T.I. no.: 2023-01 Updated: -	Topic: SCClub Software Version 2.4.2
---	---

Date: 25.01.2023	Priority	Need for action
Affected machines: SCClub	High	As soon as possible
From serial number: -	X Medium	X On next visit to the machine
As of date: Immediately	Low	FYI only

Below please find the documentation concerning the changes compared to software serial version 2.3.2. The new software version has been introduced in series in the meantime.

Service > calibration **Service routines >** **Portioner**

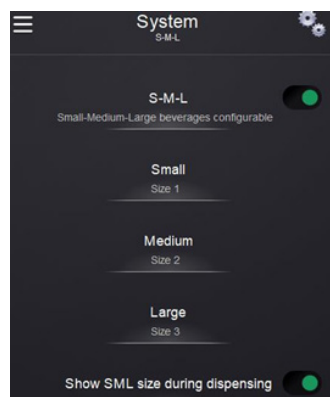
If the portioner calibration data (Pic. 1) is not kept (deactivated) during loading the factory data, it is generally recommended to carry out a portioner calibration after the upload of the factory data.

This is even more important due to the use of different grinding discs in the field, as otherwise the charge capacities of the grinder may differ considerably.
